Subject: Thermo King 1100W, 1500W and 2000W Inverters released to the market on May 15, 2014 and used with the TriPac EVOLUTION and TriPac E.

Date: August 8th, 2014

Subject: Power Inverters Recall

Subject: Power Inverters Customer Credit Return Process

Image 1

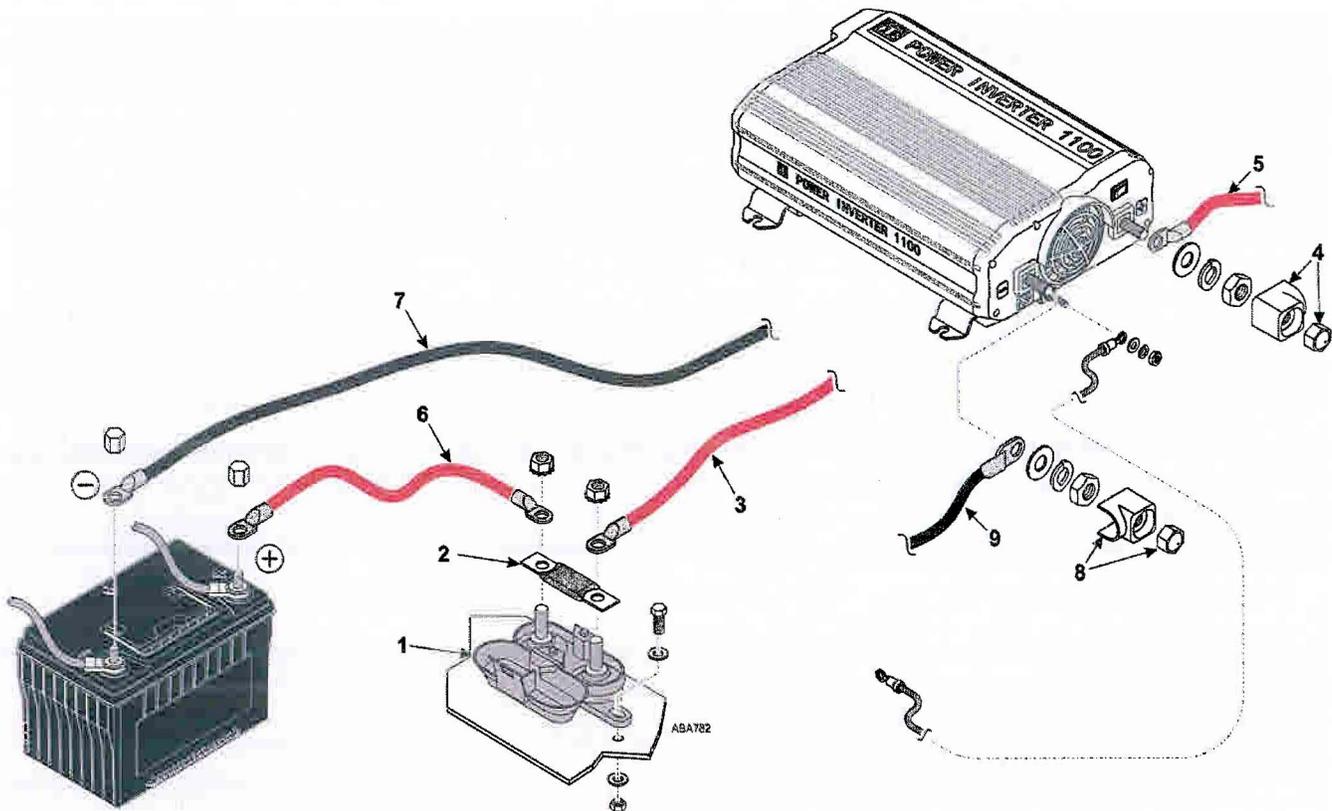
- **Inverters you have in inventory:** Do not install any of the 1100W, 1500W and 2000W Inverters that you currently have in inventory.
- **Inverters that have been installed:** Remove, and/or instruct your customers to remove the fuse from the fuse holder in the battery box on all 1100W, 1500W and 2000W Inverters that were installed on or after the May 15, 2014 release date. *See Image 1 on page 2 for more detail.*
- **Future shipments of Inverters:** Do not install future shipments of 1100W, 1500W and 2000W Inverters unless otherwise advised by Thermo King in writing.

1. Open the fuse holder cover. *Number 2 in Image 1 above.*
2. Using a 1/2 wrench, remove the nuts that secure the power cables.
3. Remove both power cables from the studs.
4. Remove the fuse from the fuse holder.
5. Reinstall the power cables onto the studs.
6. Install the nuts to secure the power cables and torque to 120 in-lbs.
7. Close the fuse holder cover.
